May 19, 2025
Subject: Ultra-thin Wearing Course
WIN: 028870.00
Location: **Farmington-Phillips**
Amendment No. 2

Please make the following changes to the Bid Documents:

NOT TO SCALE		STATE OF MAINE	
FARMINGTON - PHILLIPS		DEPARTMENT OF TRANSPORTATION	
ROUTE 4		2887000	
TYPICAL SECTIONS		WIN 28870.00	
HIGHWAY PLANS		2 OF 11	
SHEET NUMBER		2 OF 11

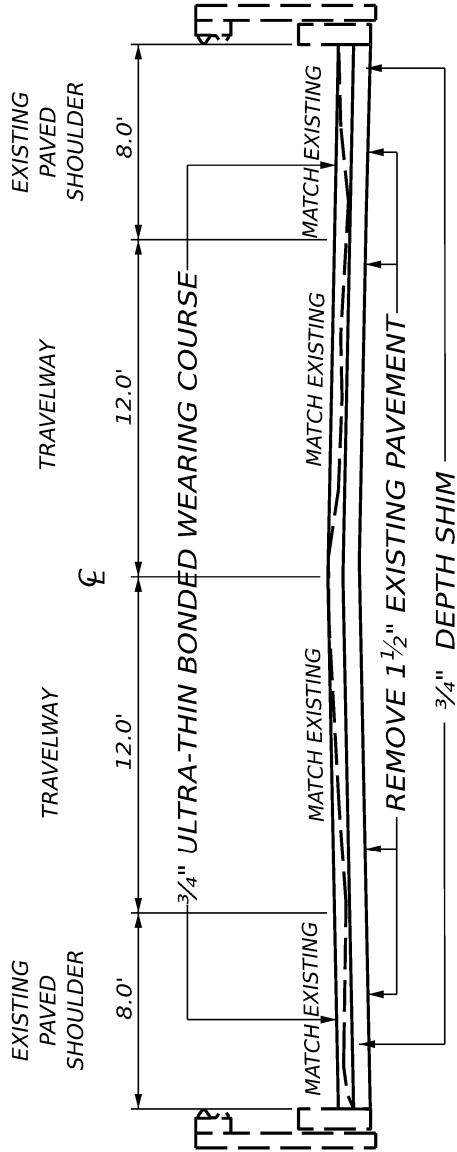
Remove Typical 2 of 11 pg 37 and **Replace** with attached

3/4" ULTRA-THIN BONDED WEARING COURSE

BRIDGE #2271 MILLING TYPICAL

STATION TO STATION
49+73 TO 52+35

NOTE: CORES WILL BE TAKEN BY THE CONTRACTOR TO CONFIRM THE DEPTH OF EXISTING PAVEMENT ON THE BRIDGE PRIOR TO ANY PAVEMENT BEING REMOVED. THIS WILL BE CONSIDERED INCIDENTAL TO ITEM 202.2.023

NOT TO SCALE		STATE OF MAINE	
FARMINGTON - PHILLIPS		DEPARTMENT OF TRANSPORTATION	
ROUTE 4		2887000	
TYPICAL SECTIONS		HIGHWAY PLANS	
		WIN 28870.00	
		SHEET NUMBER	
		7 OF 11

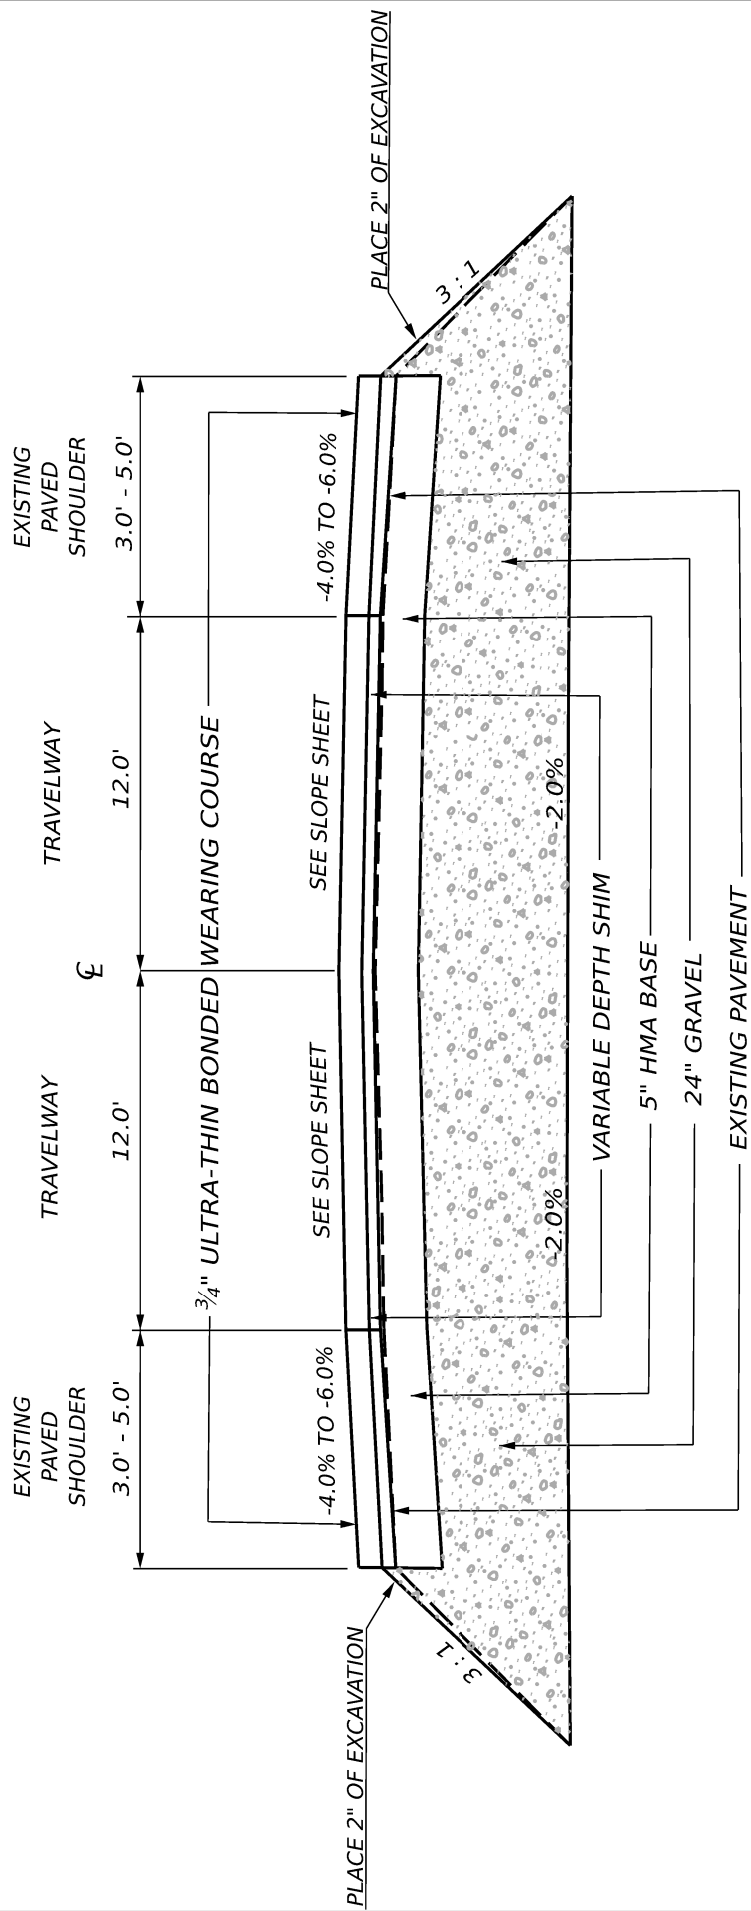
Remove Typical 7 of 11 pg 42 and **Replace** with attached

BASE REPAIR TYPICAL

STATION TO STATION

612+60 TO 615+40
1047+20 TO 1045+50

- NOTE 1 : REMOVAL OF PAVEMENT FOR RECONSTRUCTION WILL BE PAID UNDER ITEM 202.2023.
- NOTE 2 : GRAVEL TO BE PAID UNDER ITEM 304.103.
- NOTE 3 : A TEST HOLE SHALL BE DUG TO SEE WHAT IS UNDER THE PAVEMENT AND DETERMINE IF THE EXISTING MATERIAL NEEDS TO BE REMOVED AND REPLACED WITH GRAVEL. AT A MINIMUM, ALL PAVEMENT WILL BE REMOVED AND REPLACED.
- NOTE 4 : A 40 FOOT TRANSITION HAS BEEN INCLUDED IN THESE STATIONS.

FARMINGTON - PHILLIPS ROUTE 4 TYPICAL SECTIONS	STATE OF MAINE DEPARTMENT OF TRANSPORTATION		SHEET NUMBER 8 OF 11	
	WIN 28870.00	2887000	HIGHWAY PLANS

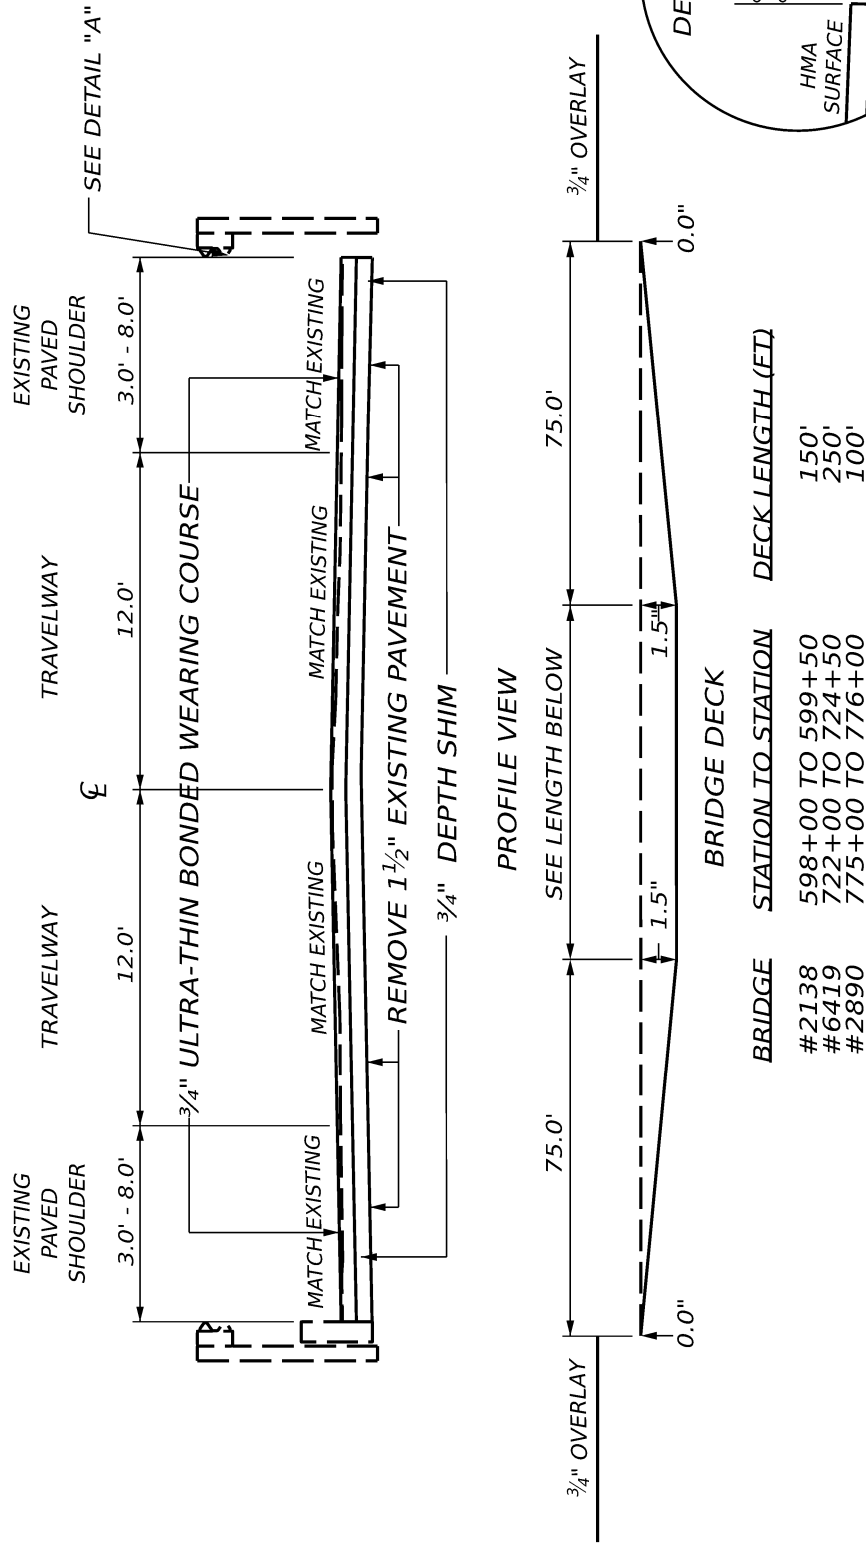
Remove Typical 8 of 11 pg 43 and **Replace** with attached

BRIDGE MILLING TYPICAL

NOTE: CORES WILL BE TAKEN BY THE CONTRACTOR TO CONFIRM THE DEPTH OF EXISTING PAVEMENT ON THE BRIDGE PRIOR TO ANY PAVEMENT BEING REMOVED. THIS WILL BE CONSIDERED INCIDENTAL TO ITEM 202.2023.
